Studebaker

SERVICE BULLETIN

NO. 248

STUDEBAKER AUTOMATIC DRIVE FOR 1951 COMMANDER AND LAND CRUISER MODELS

FIG. 1

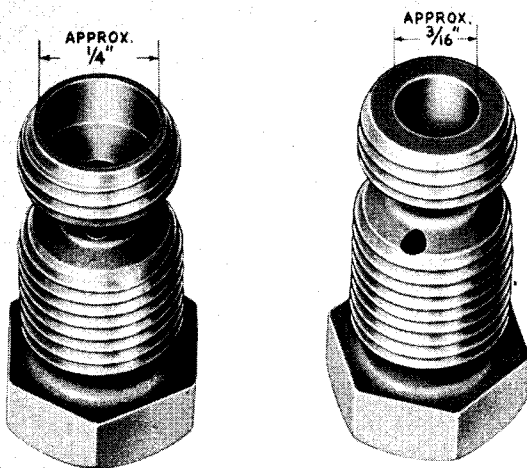
If you encounter cases of repeated excessive valve clearance developing in a Commander V-8 engine, it may be caused by excessive wear in the push rod socket of the rocker arm adjusting screws. This condition would result from screws not being properly heat treated.

Premature wear may be found in the rocker arm adjusting screw of the type shown in Fig. 1. It has not been found in the type of screw shown in Fig. 2. When you have the condition of repeated excessive valve clearance occurring examine the rocker arm adjusting screws and replace all of the type shown in Fig. 1.

Order rocker arm adjusting screws, Part No. 529400, from your Parts Depot in the usual manner. Any of these screws you receive from your Parts Depot, regardless of type, will have the proper heat treatment.
